ECE REGULATION 48

Rear direction indicator lamp and stop lamp separation

Examples and explanations

document ECE/TRANS/WP.29/GRE/2015/3

EXAMPLE 1

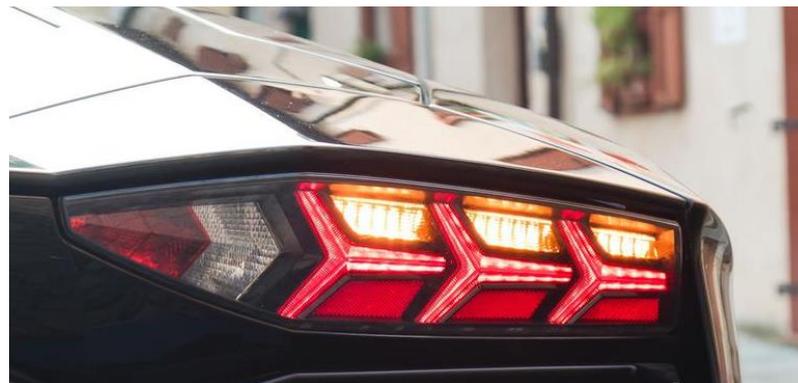
For this lamp the requirement on colour changes was not applied since the parts composing the two functions were considered not adjacent (being separated by a “neutral” area).

However this interpretation is ambiguous (“Adjacent” has slightly different meaning in different languages and whether considered as a mathematical term or not).

The text proposed for paragraph 5.7.1.3.1. clarifies the condition of application of the “colour changes” criteria, and limits the application of these criteria to lamps whose apparent surface is composed of two or more parts.

Based on the new text such a solution is acceptable as it is not detrimental for the correct perception of the signals.

EXAMPLE 3

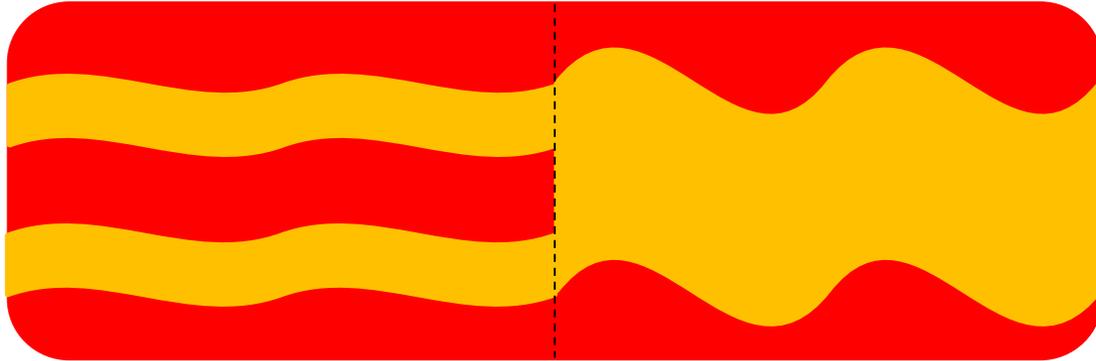
All the red area is Rear Position/Stop function

All the amber area is Rear Direction Indicator function

In application of paragraph 5.9.2. of Regulation 48, position/stop functions can be “variable lamps” changing their area/intensity in relation to the activation of another function.

In this case, at the activation of the direction indicator, the left part of the lamp (that could cause confusion for the correct perception of the signals) is switched off while the remaining part still fulfils the applicable photometric/colorimetric requirements.

Even if this possibility is already included in the requirements of paragraph 5.9.2., a cross reference is introduced in paragraph 5.7.1.3.3. to avoid non-uniform interpretations.
